P 528908

ON-SITE SEWAGE DISPOSAL SYSTEM HOWARD COUNTY HEALTH DEPARTMENT BUREAU OF ENVIRONMENTAL HEALTH

SUBDIVISION: The Chase At Storey Brook LOT NUMBER: 4

ADDRESS: 1832 Irish Eyes Lane PROPERTY OWNER: Trinity Quality Homes

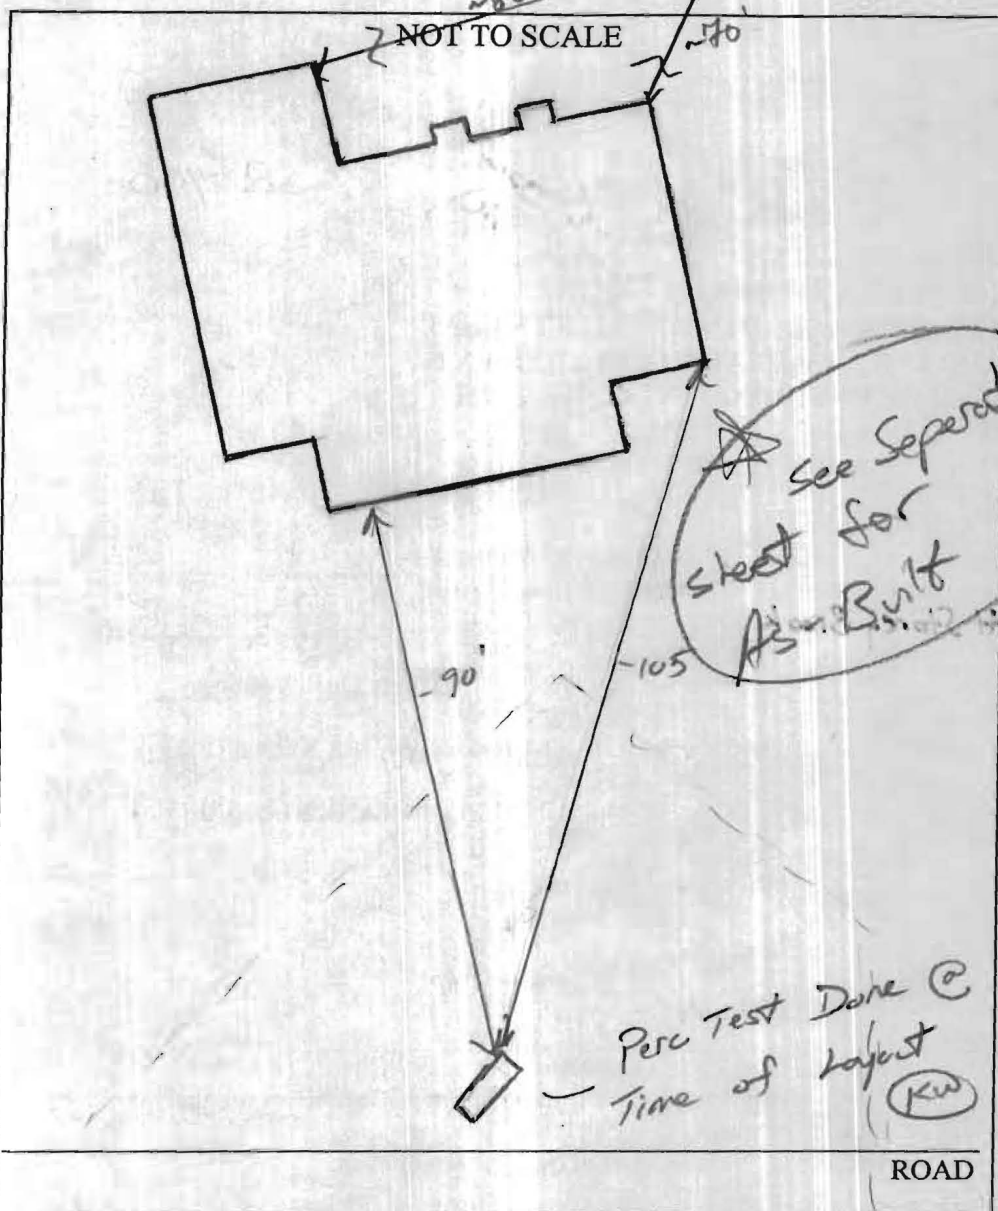
Trench 2' wide

Inlet @ 3' 8'E.T.F

LINEAR FEET OF TRENCH REQUIRED: ~~200~~ 210'

Bottom @ 7'

PRE-CONSTRUCTION 5/30/08 Perc test hole dug as shown above in support of new spec's for system. Contractor to install 3x 40' trenches on INSTALLATION contour running away from house. OK to start 80' or so out of SDA to avoid dip @ btm right corner of SDA. Tank may be set < 20' to house if builder accepts responsibility of extent. Call for inspection (KW) 6/12/08 System completed. S.T. set < 20' from house. Builder OK'd and shall send letter along w/ file for approval. OK to backfill. (KW)
